REVISIONS							2008 Interim Design Standard		Interim Date	Sheet No.
DATE	BY	DESCRIPTION	DATE	BY	DESCRIPTION		01/01/08	1 of 5		
01/01/08	SJN	Changed Pedestrian and Bicycle designations in GEOMETRY note and RAILS, PICKETS AND POSTS note. Added anchor bolt requirements to SHOP DRAWINGS note.				STEEL PEDESTRIAN/BICYCLE PICKET RAILING	Index No. 850

STEEL PEDESTRIAN/BICYCLE PICKET RAILING

Interim Date 01/01/08	Sheet No. 2 of 5
Index No. 850

DETAIL FOR NON-CONTINUOUS RAILING AT CORNERS

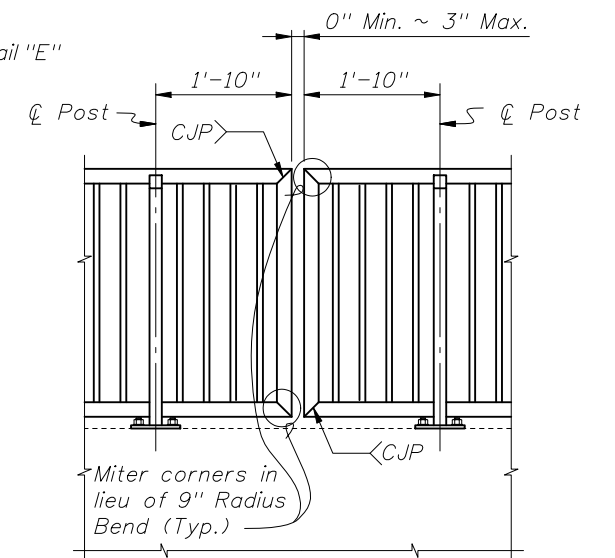
DATE	BY	DESCRIPTION	DATE	BY	DESCRIPTION
01/01/08	SJN	Added "DETAIL FOR NON-CONTINUOUS RAILING AT CORNERS" detail. Changed Pedestrian and Bicycle Railing designations, and maximum ramp lengths.

SECTION G-G
BASE PLATE & BOTTOM RAIL CONNECTION

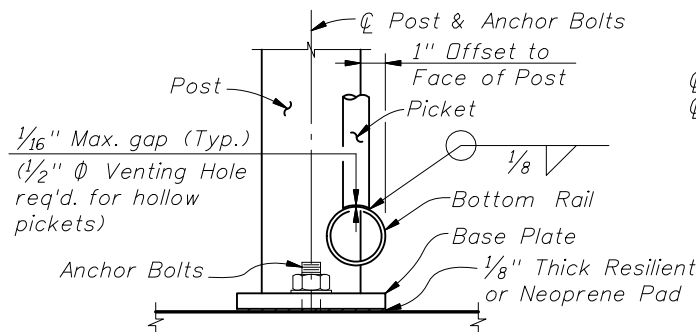
REVISIONS			
DATE	BY	DESCRIPTION	DATE
01/01/08	SJN	Added requirement for set screw to be set flush against outside face of rail and 18-8 Alloy option in DETAILS "D" & "E", option to notch post in Section G-G, and 1/4" joint tolerance in Detail "D".

DETAIL "F" (OPTIONAL SHIMMING DETAIL FOR CROSS SLOPE CORRECTION) (Used in lieu of Beveled Shim Plates)

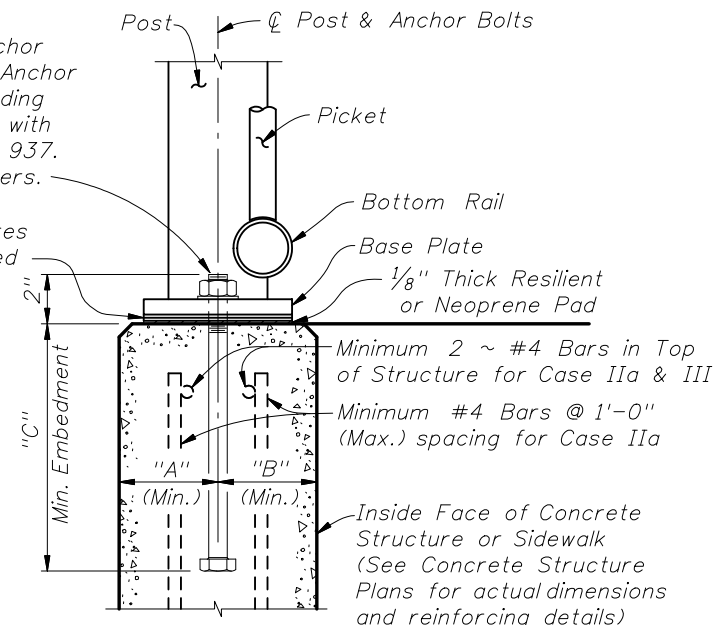
DATE	BY	DESCRIPTION	DATE	BY	DESCRIPTION
01/01/08	SJN	Added "DETAIL "F" (OPTIONAL SHIMMING DETAIL FOR CROSS SLOPE CORRECTION)", and note (*) to ANCHOR BOLT TABLE. Changed Pedestrian and Bicycle Railing designations. Corrected height on steps to top of nosing.
